# HISTORIC AND DESIGN REVIEW COMMISSION

**HDRC CASE NO:** 2022-056  
**ADDRESS:** 555 S ALAMO ST  
**LEGAL DESCRIPTION:** NCB 901 BLK LOT 44, 45 & 46  
**ZONING:** D, H, RIO-3  
**CITY COUNCIL DIST.:** 1  
**DISTRICT:** La Villita Historic District  
**APPLICANT:** James McKnight/Brown & Ortiz, PC  
**OWNER:** Eric Stone/AUTO HOTEL LLC  
**TYPE OF WORK:** Construction of a fitness center, construction of accessory structures, site modifications,  
**APPLICATION RECEIVED:** January 14, 2022  
**60-DAY REVIEW:** Not applicable due to City Council Emergency Orders  
**CASE MANAGER:** Edward Hall

**Historic and Design Review Commission**  
***Design Review Committee Report***

02 FITNESS CENTER - SOUTH ELEVATION  
3/16" = 1'-0"

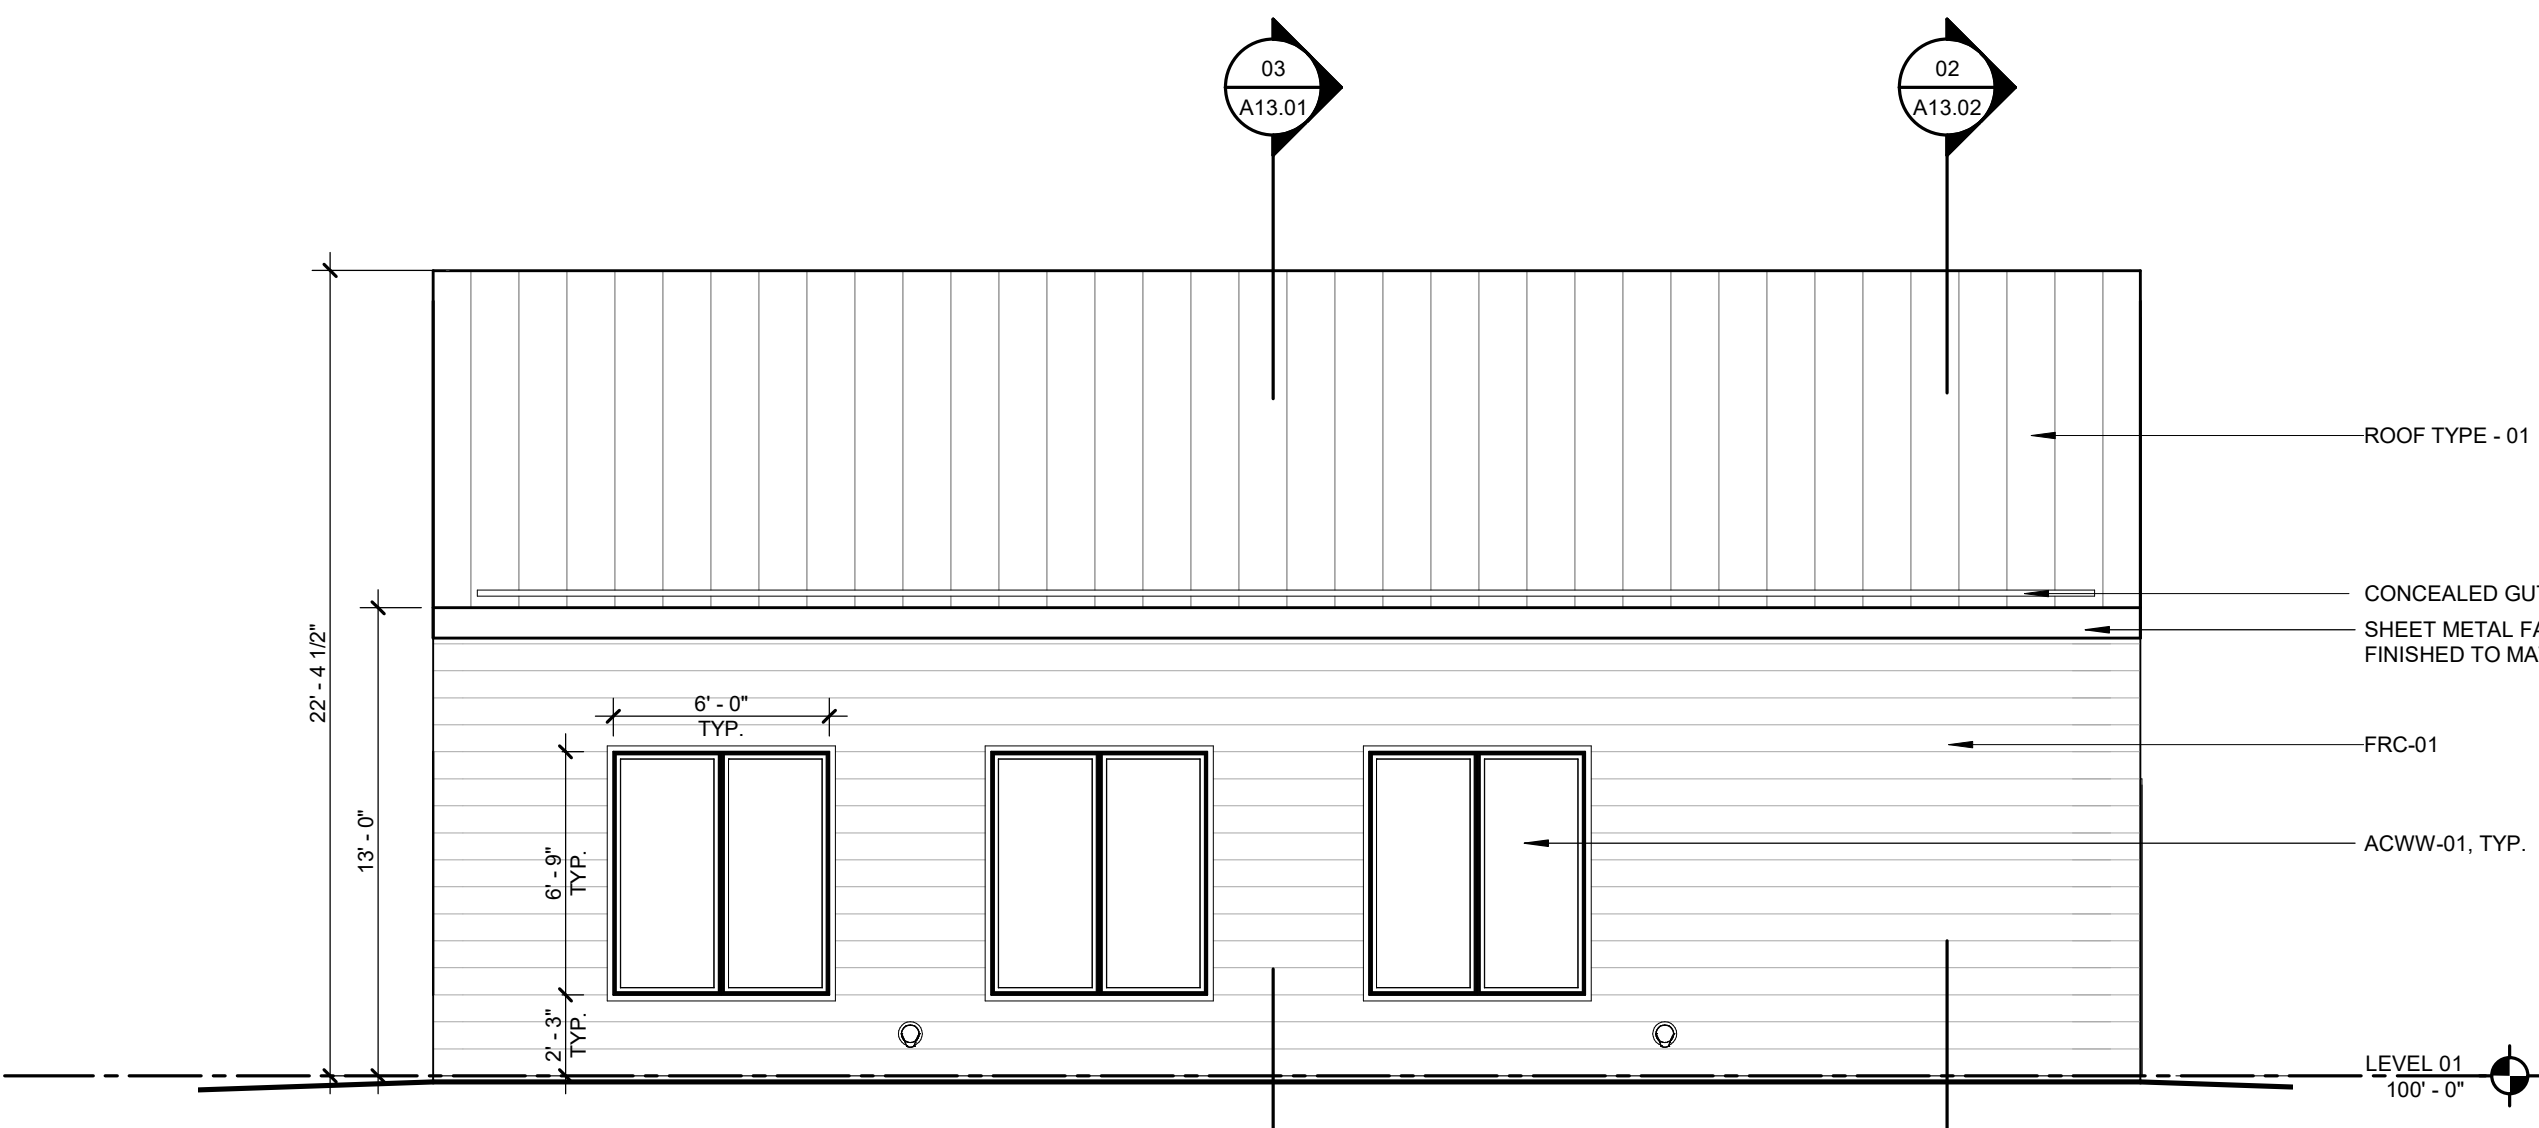
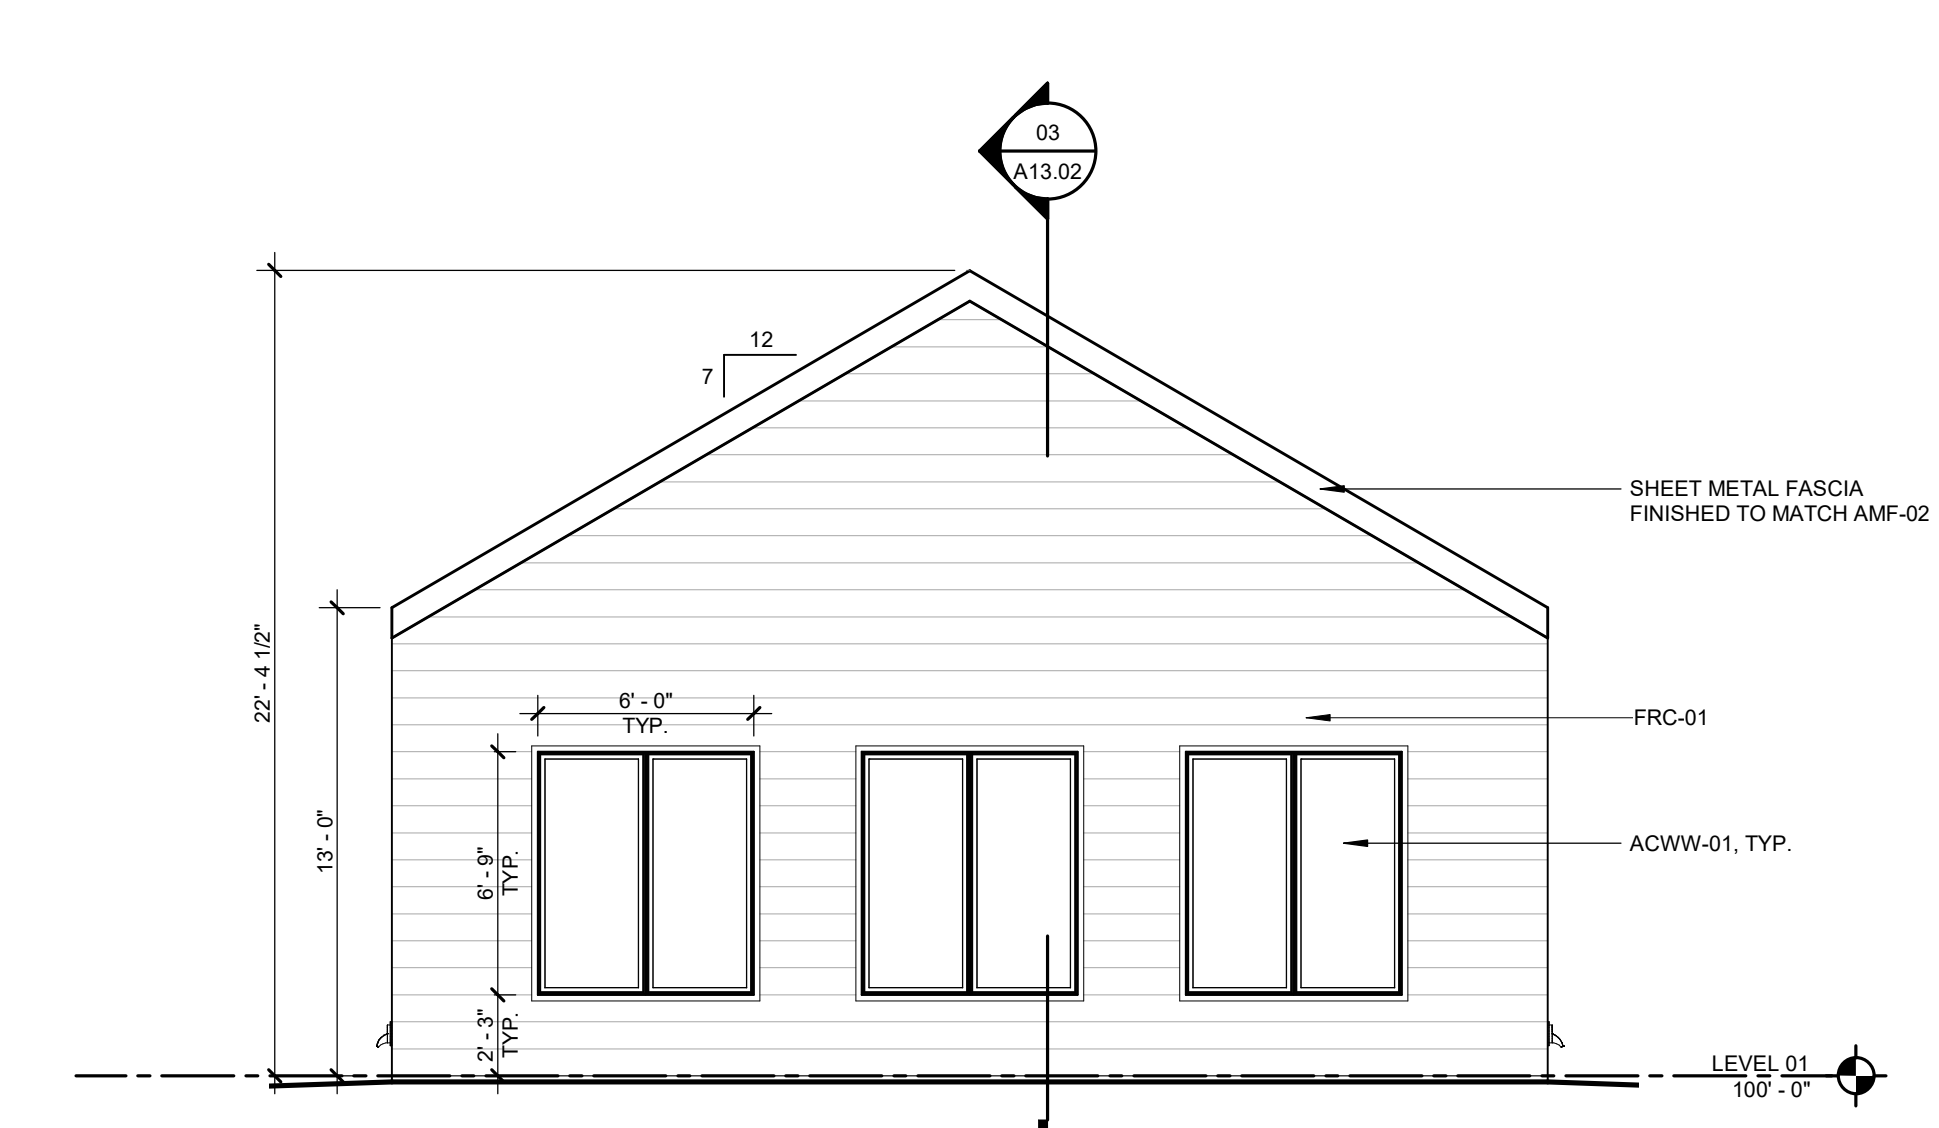
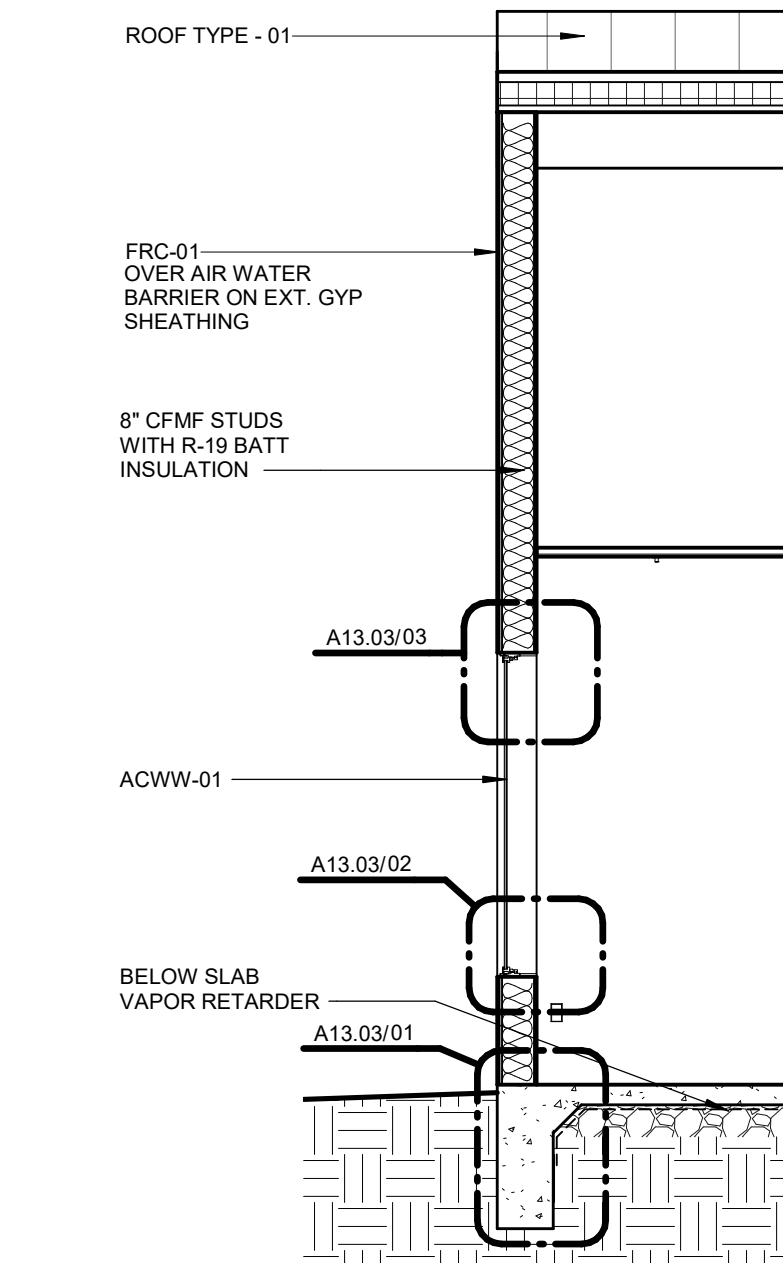
- g. **FITNESS CENTER (Setback)** – The applicant has proposed a setback on S Presa that is greater than that of the adjacent Staffel House. Staff finds the proposed setback to be appropriate and consistent with the Guidelines.

- h. **FITNESS CENTER (Materials)** – The applicant has proposed materials for the fitness center that include standing seam metal roof, composite wood panels feature a smooth finish and horizontal profile and metal windows and doors. Staff finds that the proposed standing seam metal roof should feature panels that are 18 to 21 inches wide, seams that are 1 to 2 inches in height and a crimped ridge seam. A low profile ridge cap may be submitted for review and approval by the Commission for new construction. Generally, staff finds the proposed zinc finish for the metal roof to be appropriate as it is comparable in color to the standard galvalume finish. The composite siding should feature a four (4) inch exposure.

- i. **WINDOWS** – The applicant has proposed to install metal windows that will feature dark frames and be recessed two inches within wall openings. Staff finds this to be appropriate.

MS: Questions about the general design of the fitness center. Has the setback been increased? ZJ: Yes, the setback has been increased eight feet, the depth of the porch of the historic structure.

- 1. Staff recommends approval of item #1, the construction of an event structure as submitted based on finding d.
- 2. Staff recommends approval of item #2, the construction of a pool structure as submitted based on finding e.
- 3. Staff recommends approval of item #3, the construction of a fitness structure based on findings f through j with the following stipulation:
  - i. That the proposed composite siding feature a smooth finish and an exposure of four (4) inches.
